Subject: Addendum to the bushfire attack level assessment for Cadence Estate, stages 2a and 2b – 145 Binnies Road and 143-163 Daleys Road, Ripley, Queensland

Bushfire Attack Level Assessment
 145 Binnies Road &
 Project 143-163 Daleys Road, Ripley

FIGURE
1

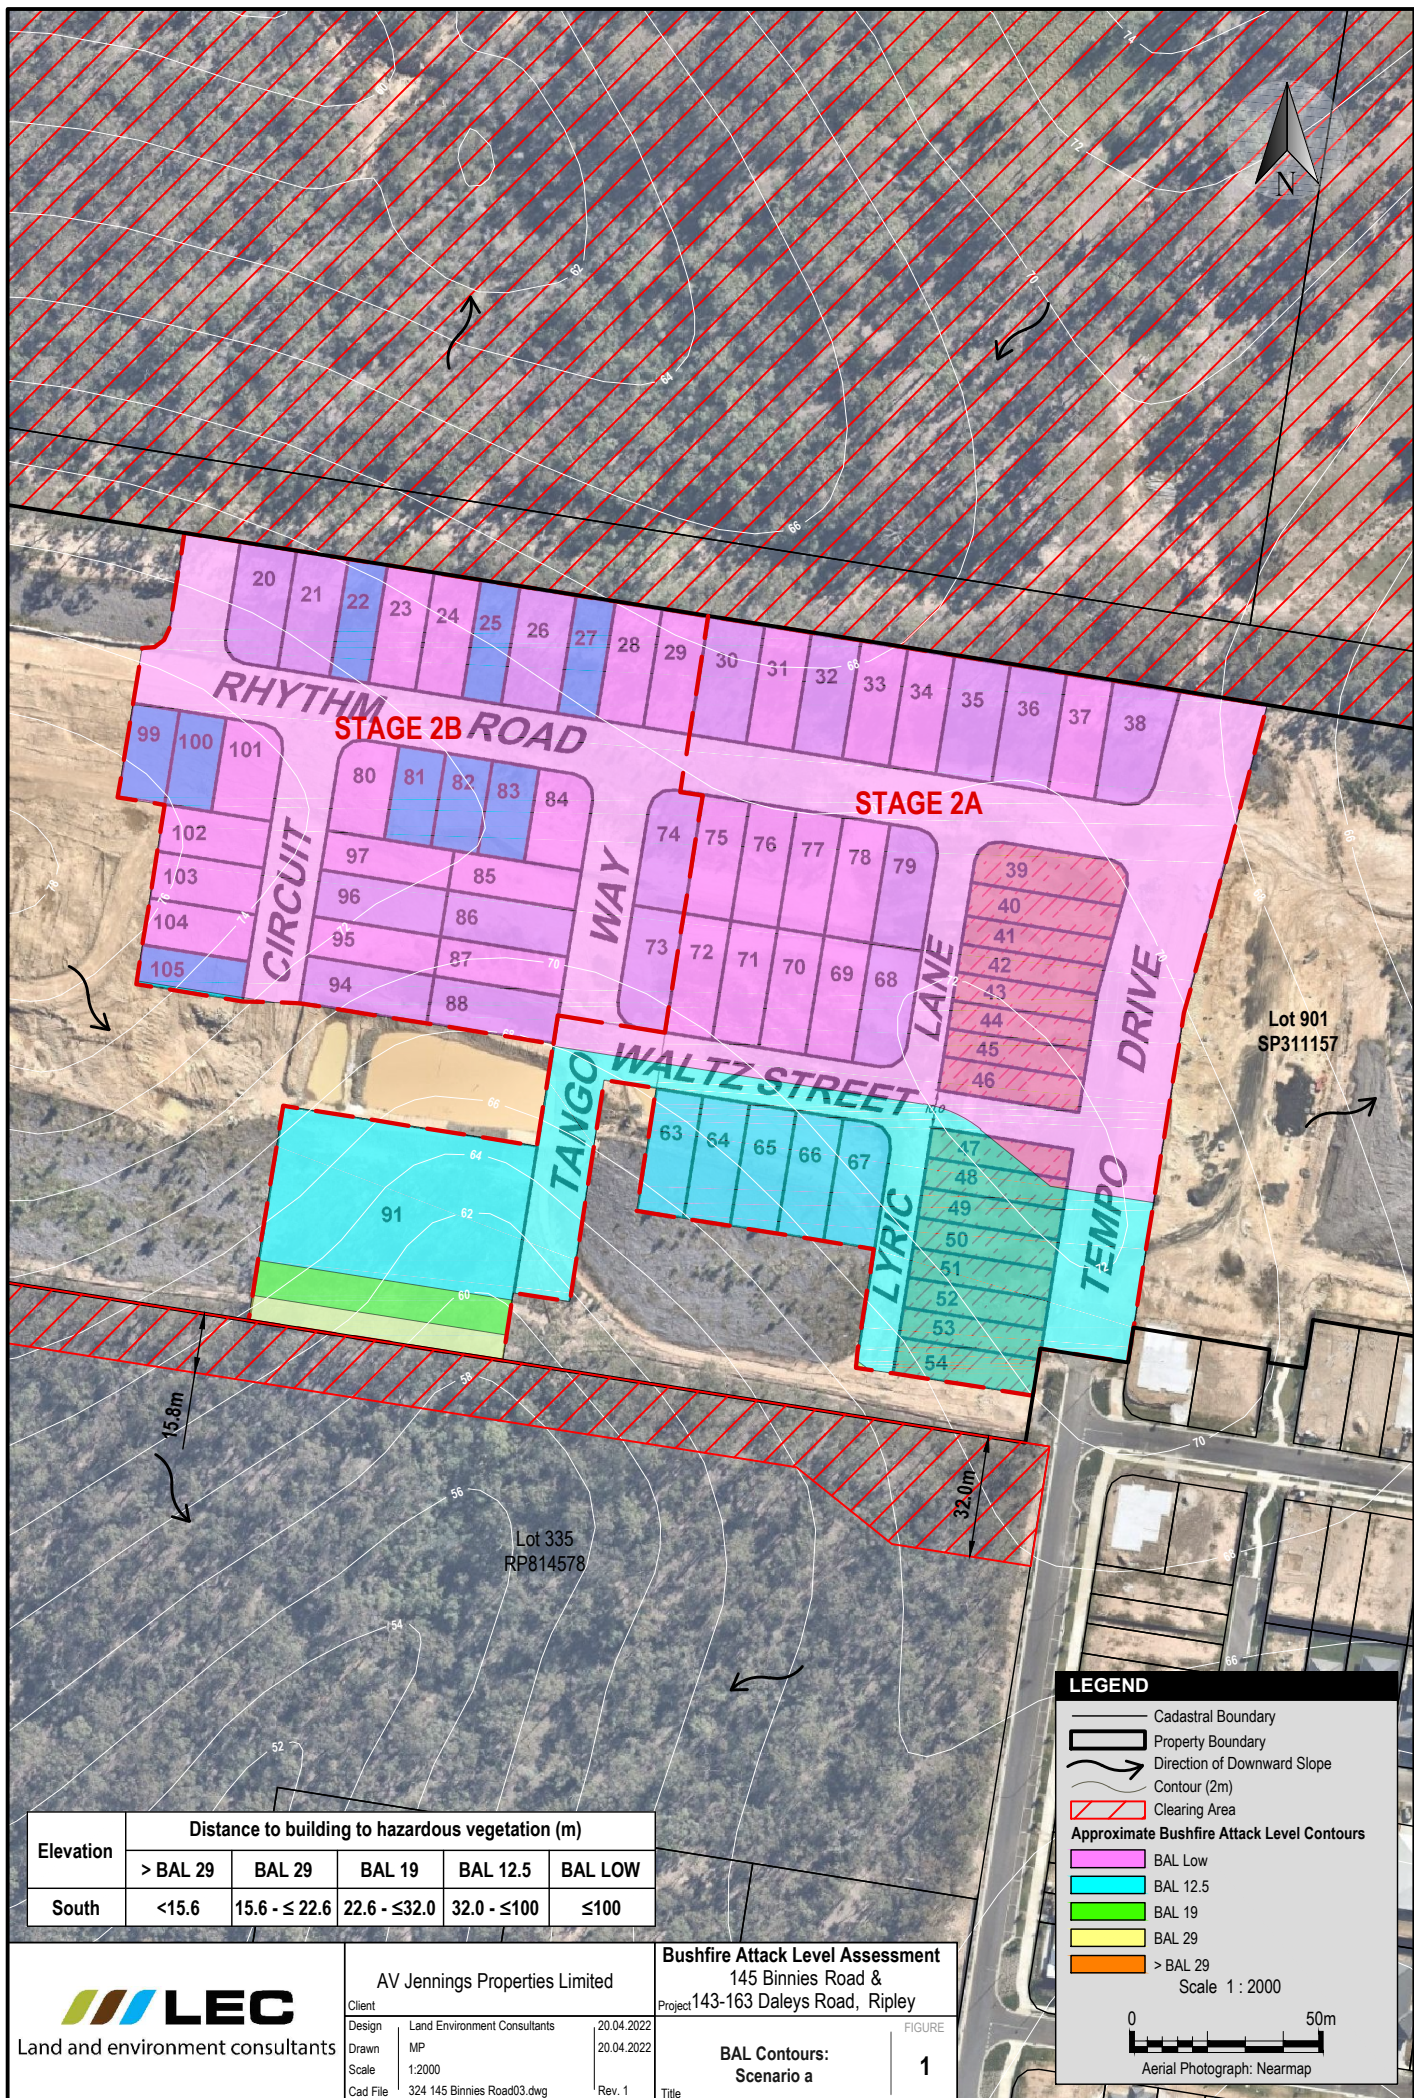
Since the BAL assessment for stages 2a and 2b was prepared in November 2021, vegetation has been cleared from land within 100 m of the northern boundary of stages 2a and 2b. This report documents the revised BAL assessment for lots within stages 2a and 2b based on the recently cleared vegetation along the northern boundary of the stages 2a and 2b and two scenarios of vegetation retention/management adjoining the southern boundary of stages 2a and 2b. The two scenarios are as follows:

- a) a corridor of vegetation is cleared from the southern boundary of stages 2a and 2b as shown in Figure 1 (**Scenario a**); and
- b) vegetation is not cleared from the southern boundary of stages 2a and 2b as shown in Figure 2 (**Scenario b**).

The revised BAL contours over stages 2a and 2b which considers vegetation cleared along the northern boundary of stages 2a and 2b and Scenario a and Scenario b of vegetation retention/management adjoining the southern boundary of stages 2a and 2b are shown in Figures 1-2. The revised BAL ratings of lots within stages 2a and 2b are summarised in Table 1. Lot 91 is a drainage reserve and a BAL rating is not relevant to this lot. Therefore, it is not listed in Table 1.

BAL-LOW	BAL-12.5	BAL-19	BAL-29	> BAL-29 (No building envelope)
Scenario a – refer to Figure 1				
20-46, 68-88, 94-97 and 99-105	47-54 and 63- 67	-	-	-
Scenario b – refer to Figure 2				
20-44,74-86, 96-97, 99-103	45-51, 63-73, 87-88, 94-95 and 104-105	52-53	-	54
